MICHIGAN STATE UNIVERSITY

SUBJECT: Docket 50-294, Formal Review Questions--Your Letter Dated
May 11, 1984

Michigan State University
 Docket 50-294 Formal Review Questions, MSTR
 (Reference: NRC Letter Thomas → Wilkinson 5/11/84)

Figure 2.

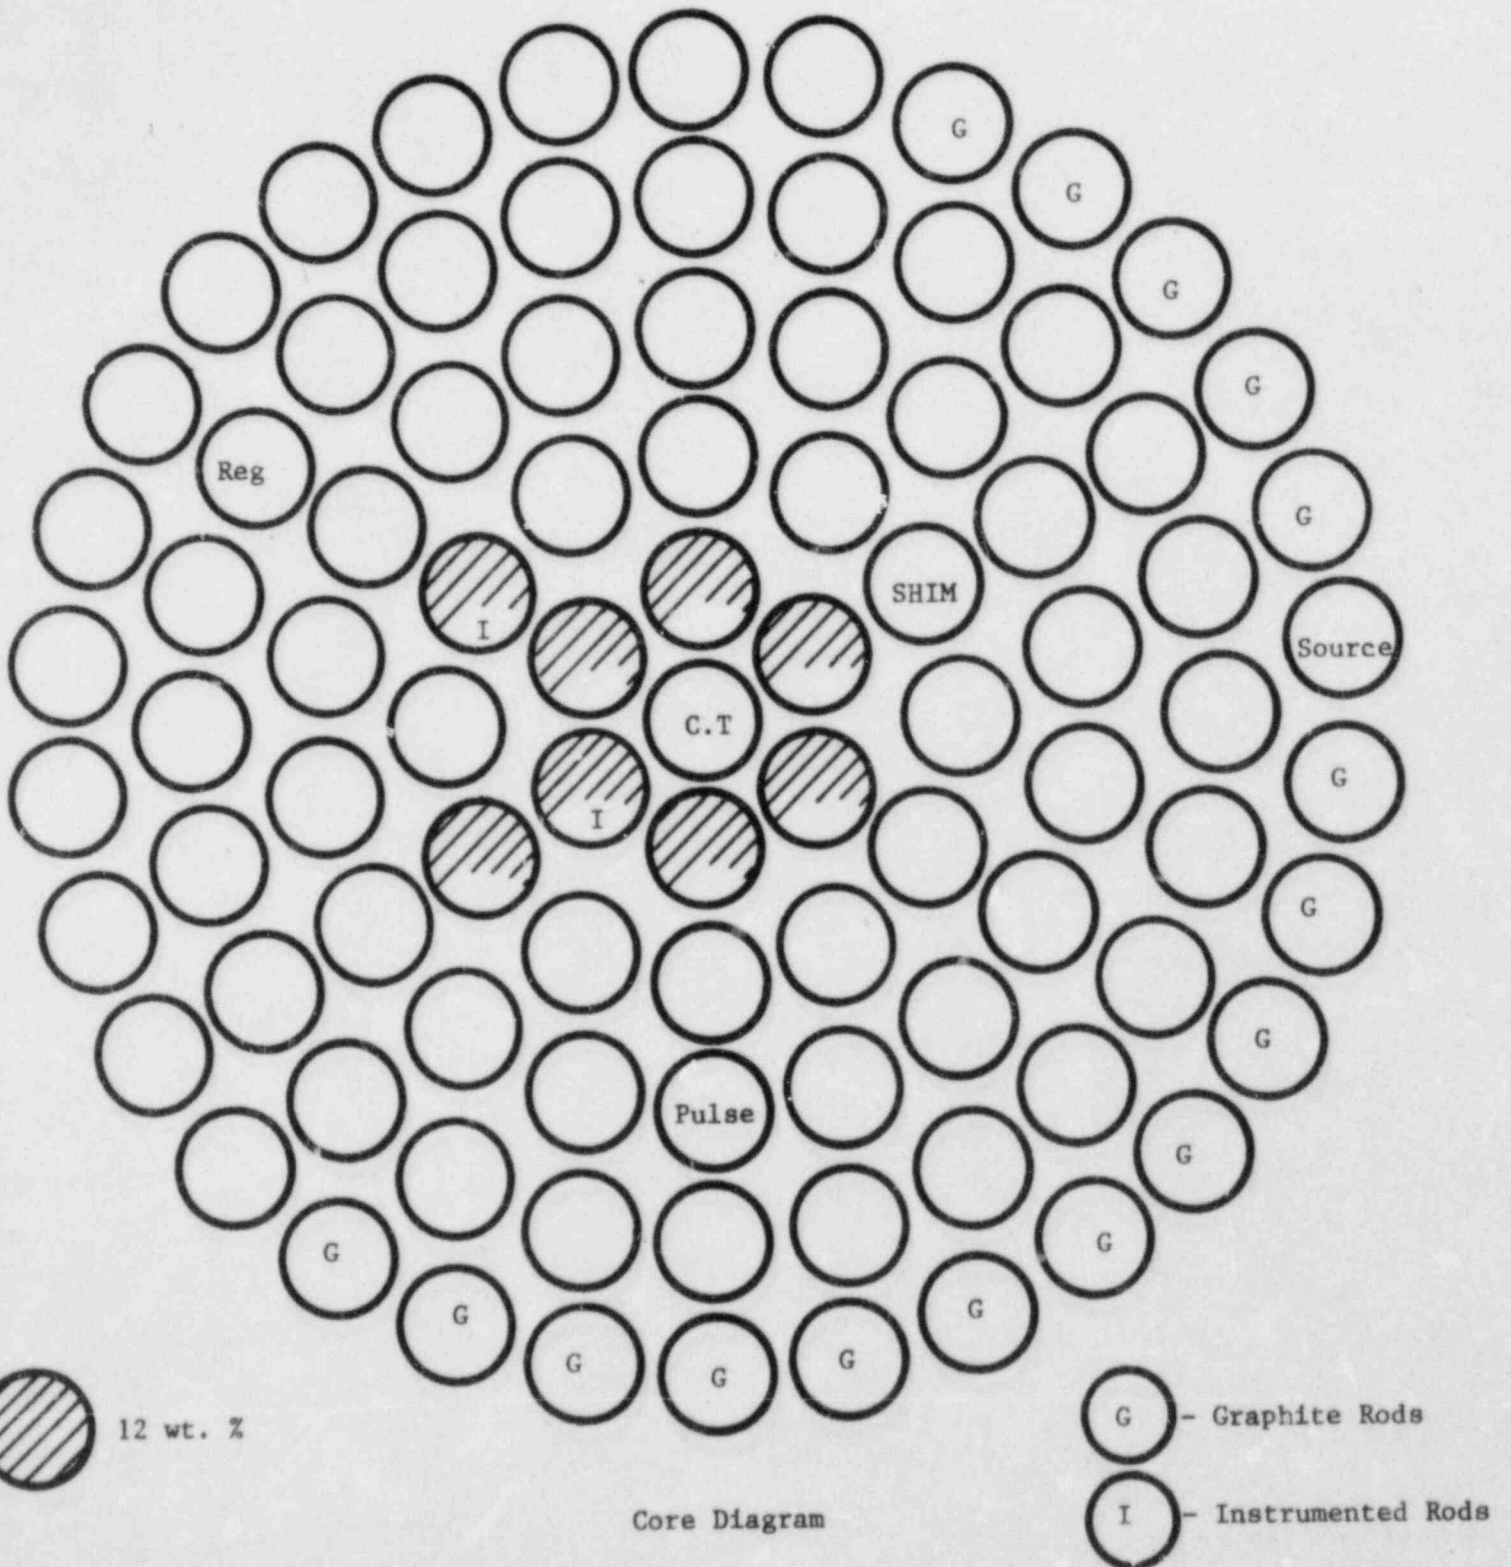
6. Provide schematic drawings of the primary cooling system and the water purification system.

Figure 2 shows the cooling system and water purification shunt. These two systems are interdependent.

Figure 1.

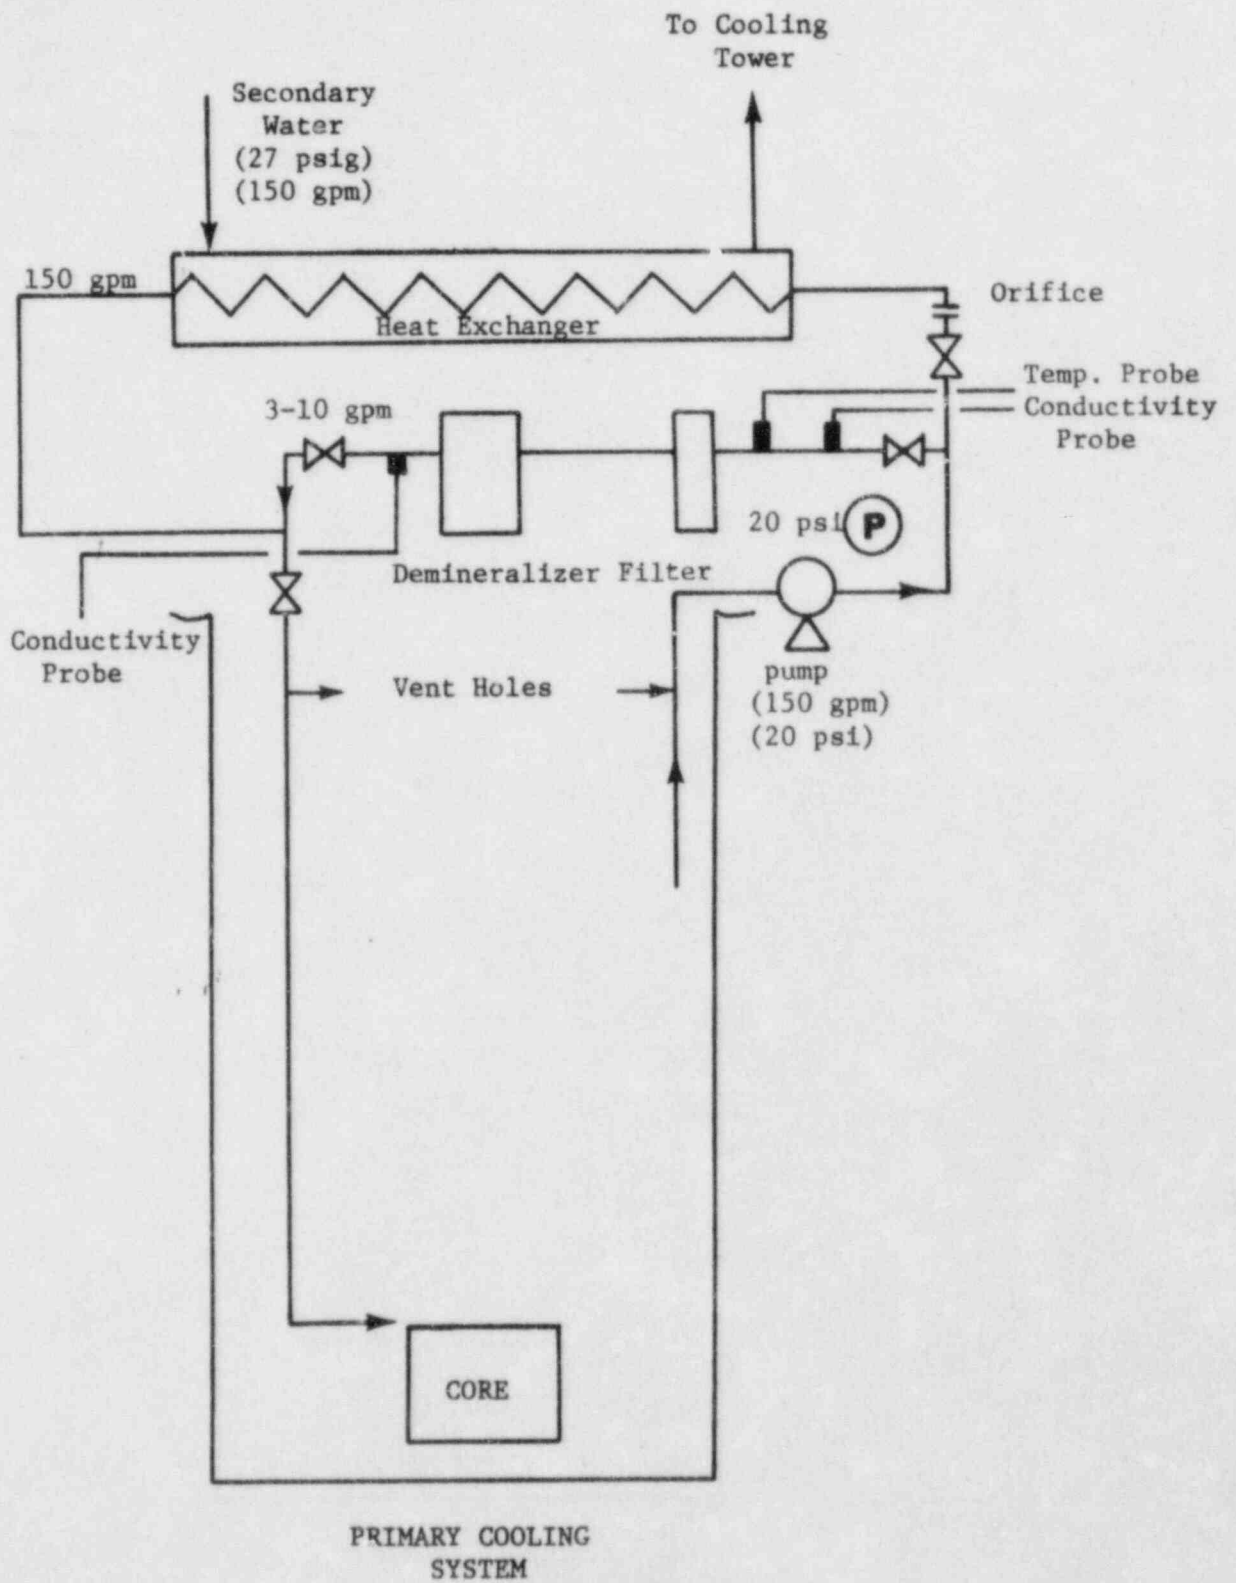
2. Provide a plan view of the current core configuration showing the number and location of the fuel elements (differentiate between 8.5 and 12 weight-per cent elements), control rods, graphite reflector assemblies, experimental tubes, and the startup source.

Figure 1 shows the current core configuration. All positions are filled with fuel elements except those marked "G", representing graphite reflector elements, the three control rod positions, marked reg. shim, and pulse, and the source position marked source. Currently there are no experiment tubes in the core grid plate except the central thimble, marked C.T.

Figure 3.

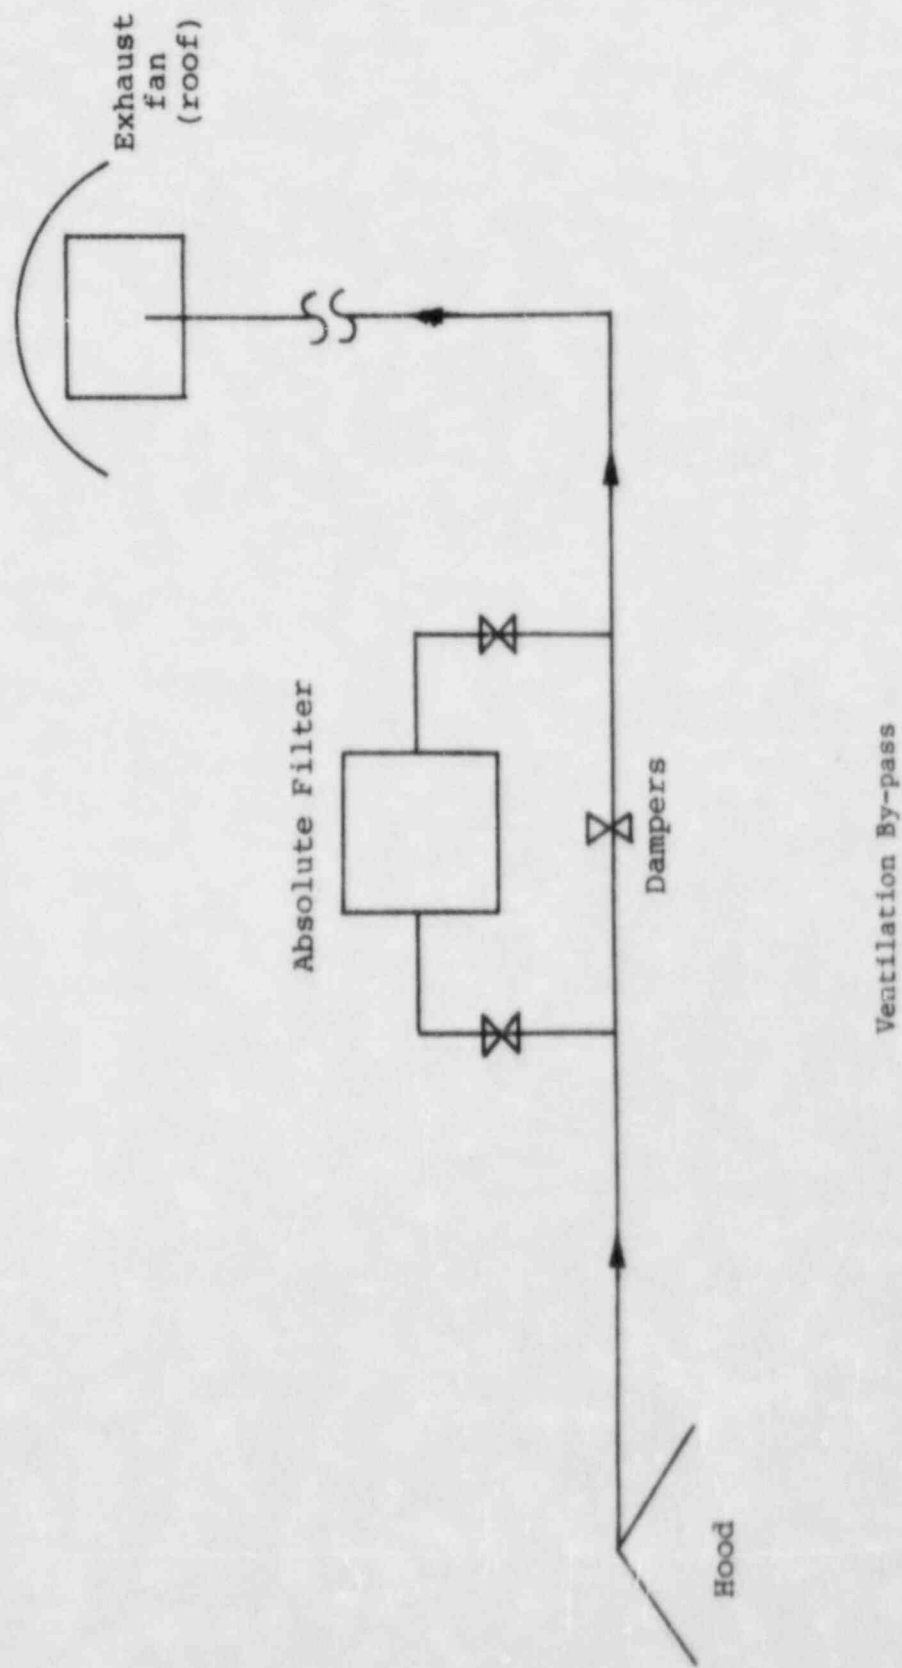
11. Provide a schematic drawing of the ventilation system by-pass through the absolute filter. How are the monitoring system and the damper function monitored and controlled from the console?

Figure 3 is a schematic of the ventilation by-pass. Damper function is monitored and controlled at the console. The operator has a button marked "vent" with dual lights to indicate damper position.

Figure 4.

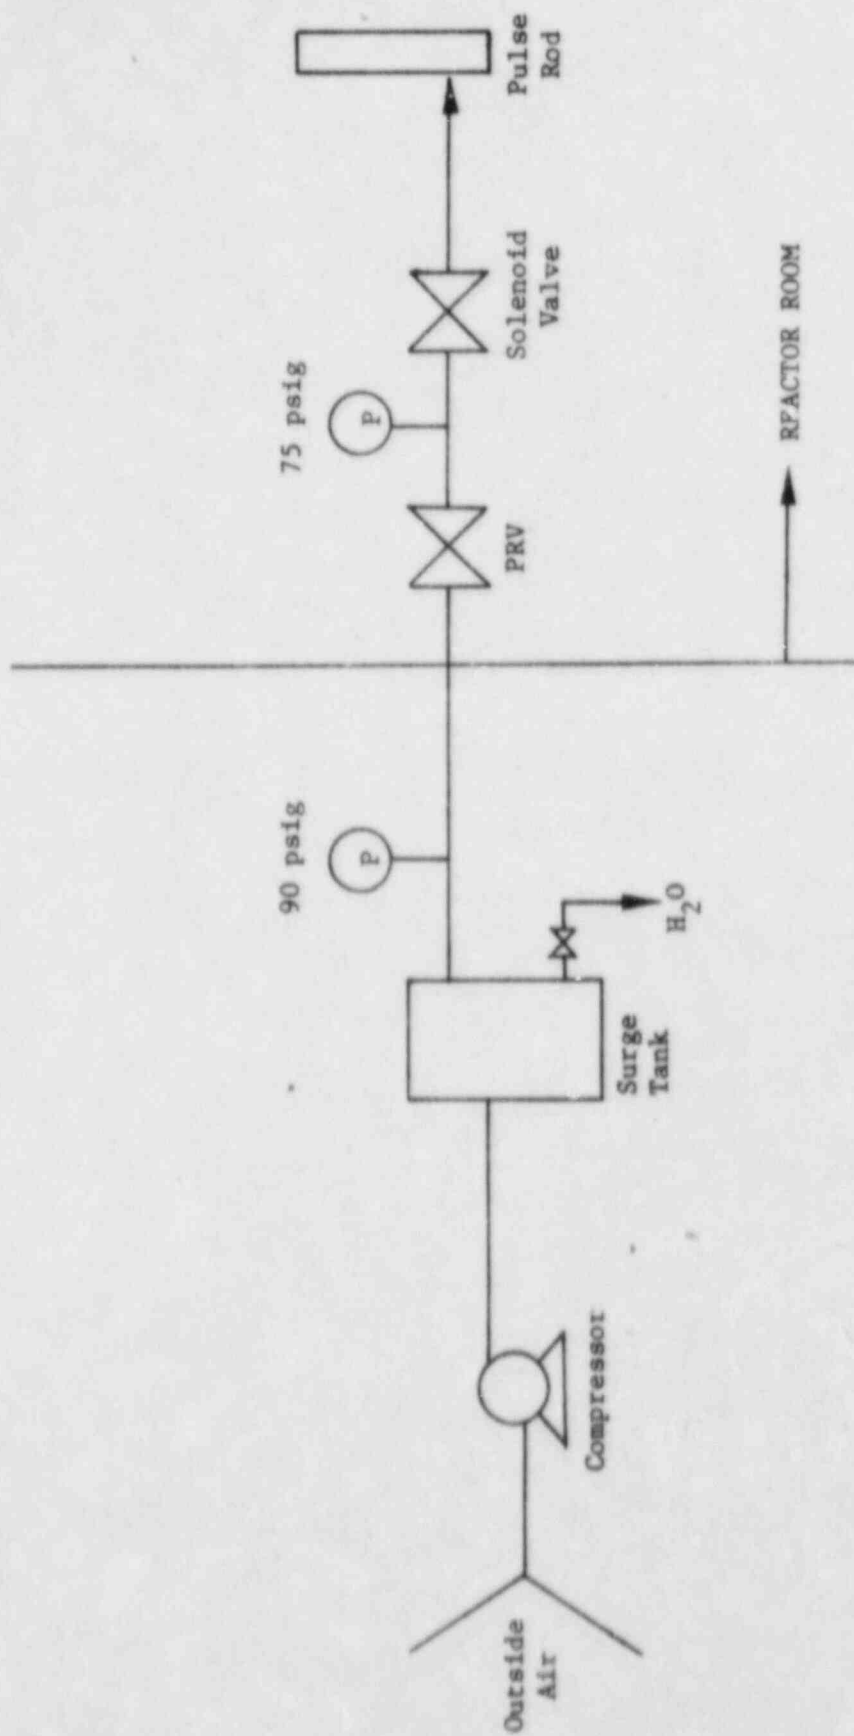
14. Describe the compressed air system(s) at the reactor facility, including details of installation and uses.

Figure 4 shows a schematic of the compressed air system to Room 184. The only use for compressed air in Room 184 is to drive the pulse rod.

Figure 5A. Block Diagram of Reactor Instrumentation for Steady-State Operation

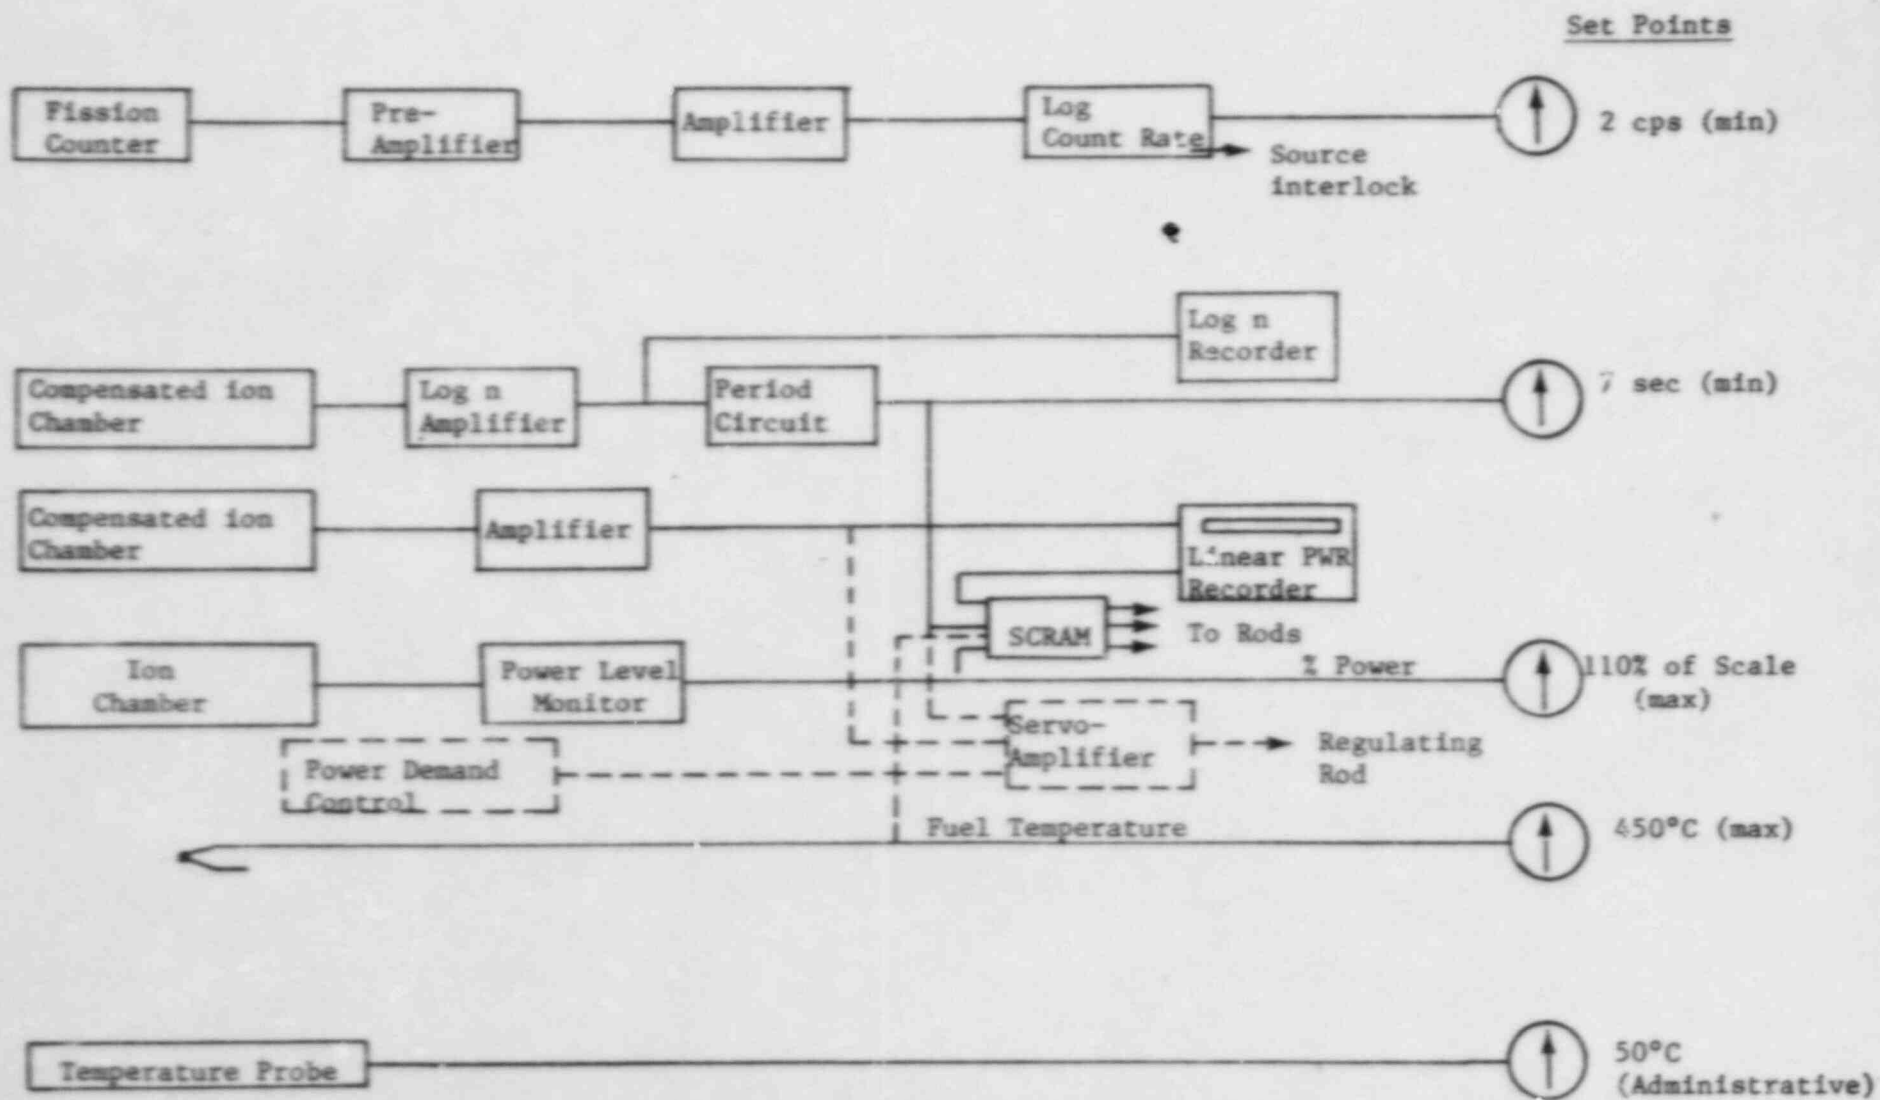
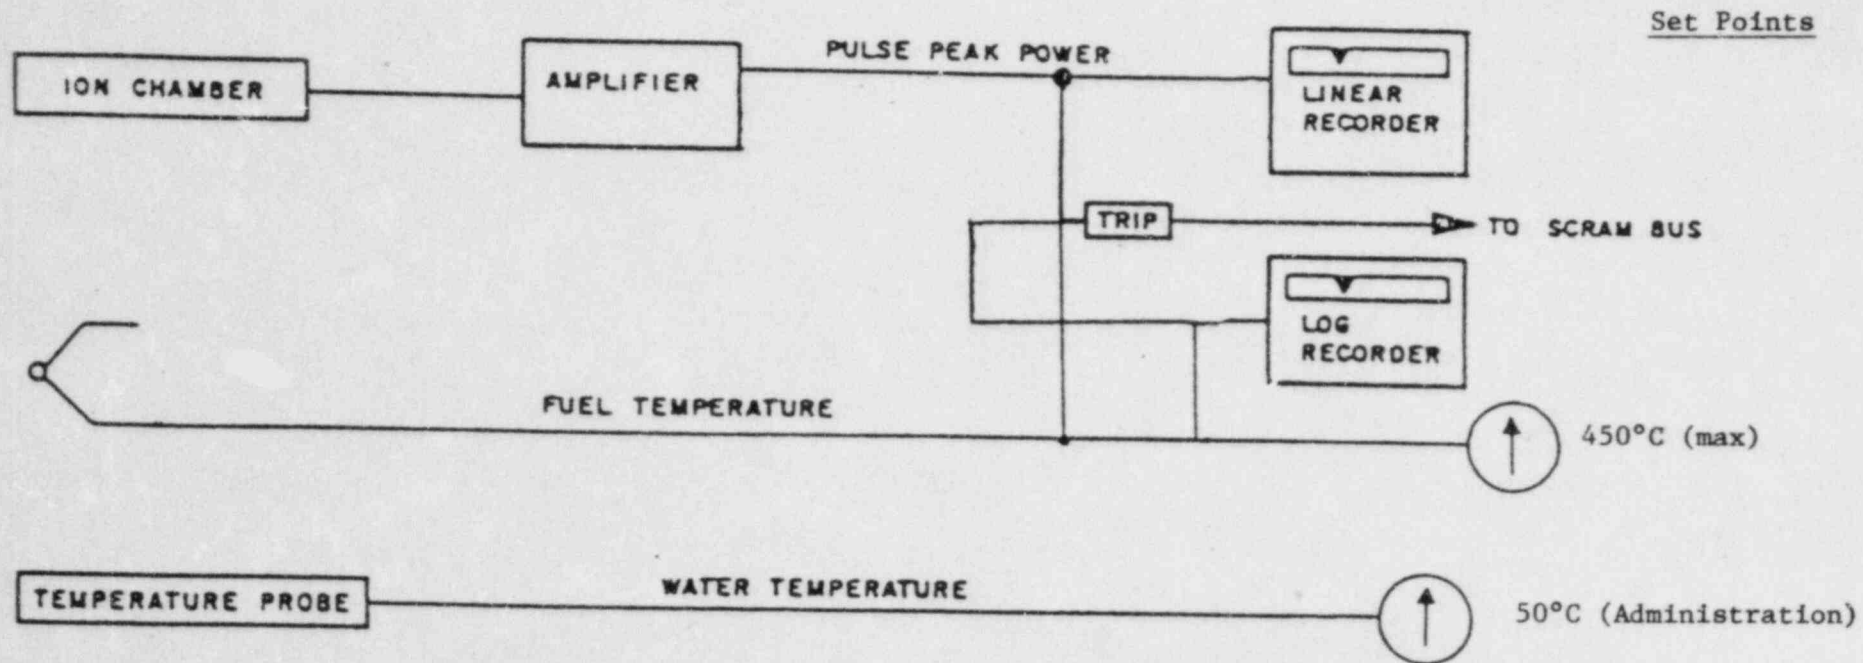
43. Provide a block diagram of the nuclear instruments control and set points. It should include the following information.
- (1) Type of channel
 - (2) Detector
 - (3) Range of detector (not meter readout)
 - (4) Automatic controls
 - (5) Set points (minimum and maximum where applicable)

Figure 5A + B are block diagrams of the instrumentation during steady state operation and pulsing respectively.
